**Item 9.****Development Application: 15 Bourke Road, Alexandria****File No.: D/2018/56****Summary****Date of Submission:** 24 January 2018**Applicant:** ABC Planning Pty Ltd**Architect:** BKA Architecture**Developer:** AMC Properties Pty Ltd**Owner:** AMC Properties Pty Ltd**Cost of Works:** \$9,365,000

**Proposal Summary:** The proposal seeks consent for demolition of the existing warehouse building and construction of a four storey commercial building with ground floor retail and basement parking.

**Summary Recommendation:** This proposal is recommended for refusal.

Figure 10: Proposed ground floor

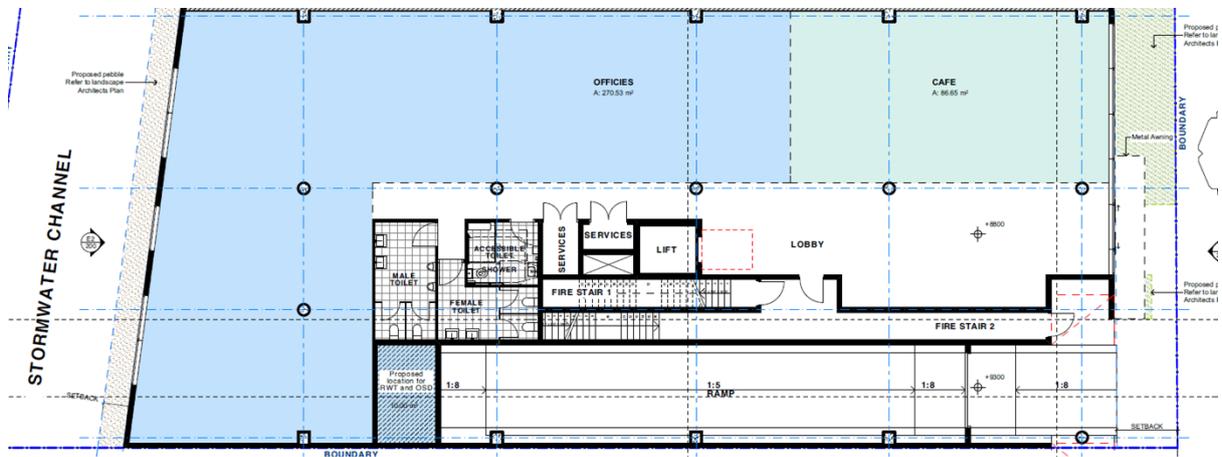
The application proposes a retail use on the ground floor (however, the plans annotate this space as a café). Retail premises are prohibited in the B7 business park zone.

5.2.7 Stormwater management and waterways	No	See clause 3.7 above.
5.2.9 Building design	No	The proposed building entry will not provide a clear transition from the street as required by this control. The lobby is formed as a 16m narrow and deep passageway with no daylight or visual relief and no transition from Bourke Road. A better sense of arrival should be provided. The entry is not clearly legible or differentiated from the café tenancy.

50. The site is identified as being flood prone. The minimum flood planning level for the access ramp to the basement, fire stair and lobby is to be 10.25m AHD. The minimum flood planning level for the café and office spaces is to be a minimum of 8.86m AHD.
51. The existing drawings show the ramp to the basement as being 9.3m AHD and the lobby being 8.8m AHD, as opposed to being at 10.25m AHD. In addition, the retail/café are shown as being 8.8m AHD, as opposed to the required 8.86m AHD. These levels do not comply with the City's interim flood policy (section 5 - minimum flood planning level).

Figure 15: Proposed south (Bourke Street) elevation

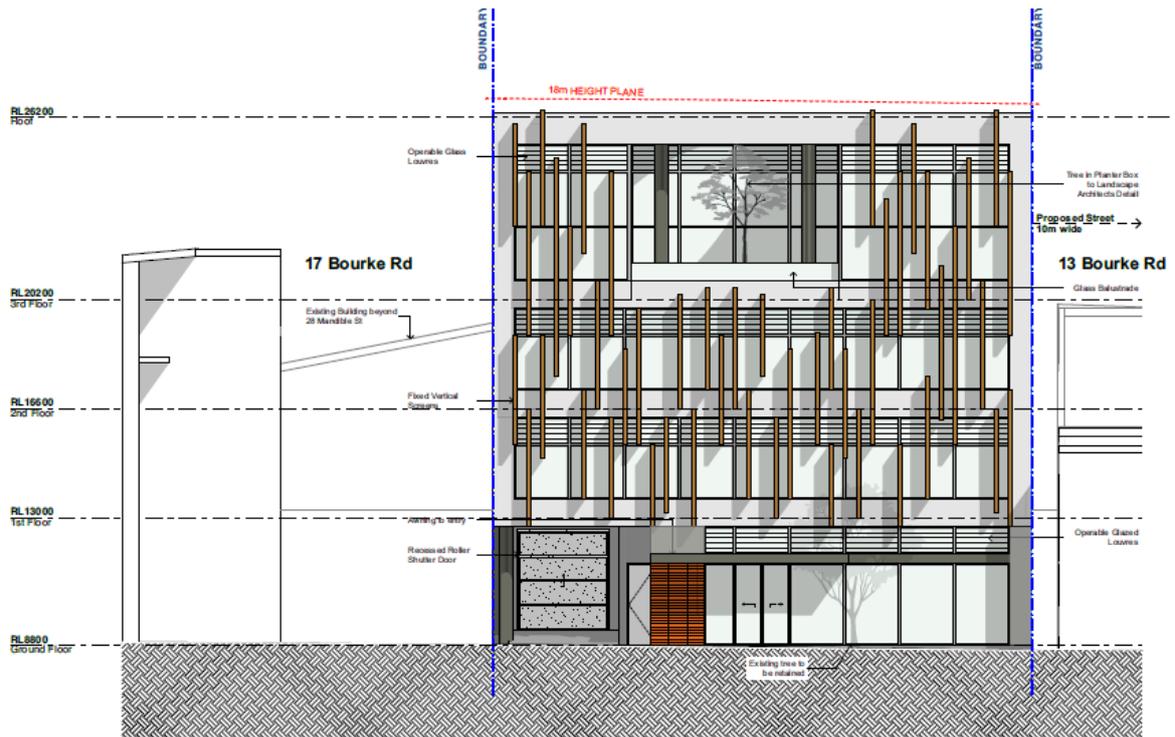
56. The site includes a 2.4 metre public domain setback for the front facade for footpath widening. In accordance with table 5.13 in section 5.8.2.2 of the Sydney DCP 2012, the land is to be dedicated to Council for the purpose of footpath widening. In addition, it is to be provided clear to the sky. While a setback is provided, it is not proposed to be dedicated to Council and is not provided clear to the sky. That is, the building facade overhangs the proposed 2.4 metre setback. This is not acceptable.

63. The proposed elevations show a vehicle door height of approximately 3.6 to 3.7 metres. The traffic report acknowledges occasional large service/delivery vehicles will use the street parking. There is a separated cycleway outside the site and the on-road separator has a large gap because of a number of consecutive driveways. This commonly results in large trucks stopping in the cycleway.
64. Given this, the development should be designed to allow for loading and collection within the basement. As this is a new building, a greater vehicle door height of approximately 4.5 metres should be provided. This will enable a greater number of vehicle types to load and unload within the site, as opposed to on the street.

Figure 18: Proposed east elevation (fronting future Road)

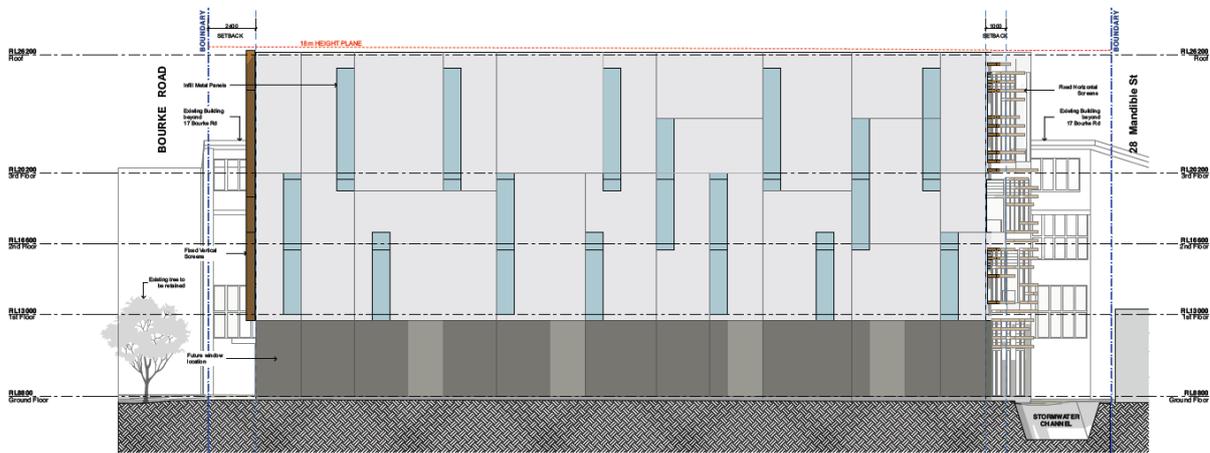
61. The eastern side of the proposed design will present a 37 metre flat and solid 4 storey frontage with metal infill panels and precast concrete to the future street. The concept for conversion elevation, DA202, revision 1, provides for future glazing. However, this option does not form part of the approval. It also does not maximise opportunities to provide articulation and facade modulation. These would allow for a more active and landscaped edge condition and future surveillance of the street. Given the FSR exceedance, a better engagement with the future public domain should be provided.

62. In addition to this, given this side boundary is proposed to become a new street, this side of the building should provide a minimum landscaped setback of one metre in accordance with section 5.2.10(2) in the Sydney DCP 2012. This is to ensure that the development provides a high quality frontage and appropriate presentation to the public domain.

**Figure 23:** Proposed future road in accordance with Sydney DCP 2012

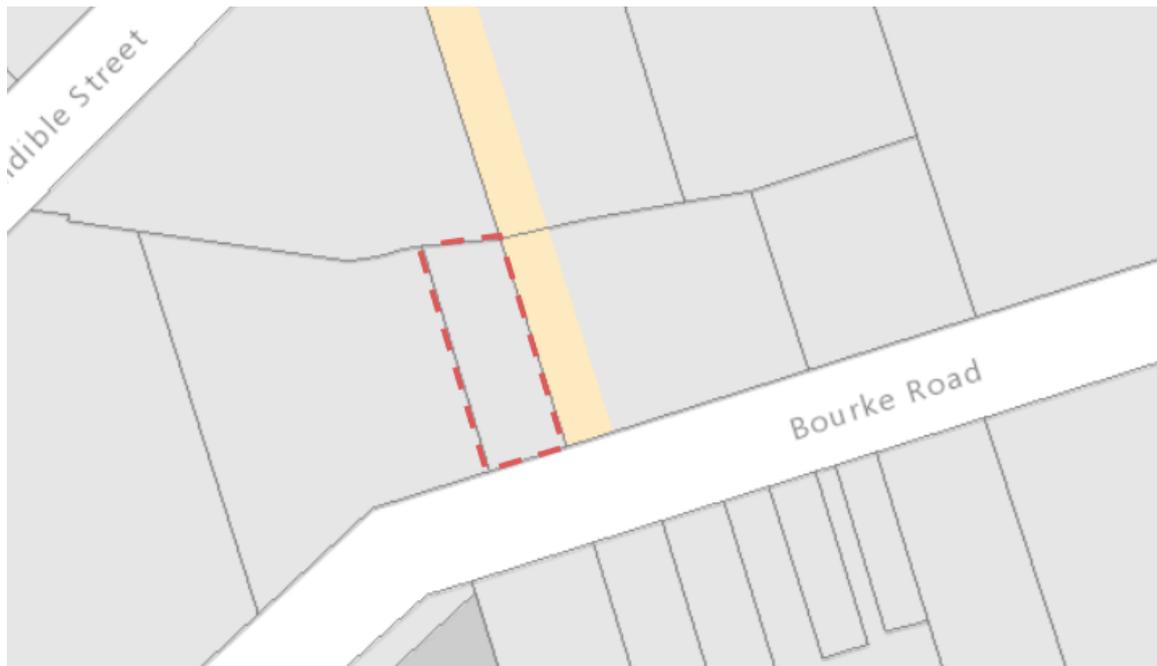
60. The site is located adjacent to a future proposed street, as identified in figure 5.35 in section 5.2.4.1 of Sydney DCP 2012 and figure 1.84 in section 5.8.3.2 of Sydney DCP 2012. This is shown in the figure below.
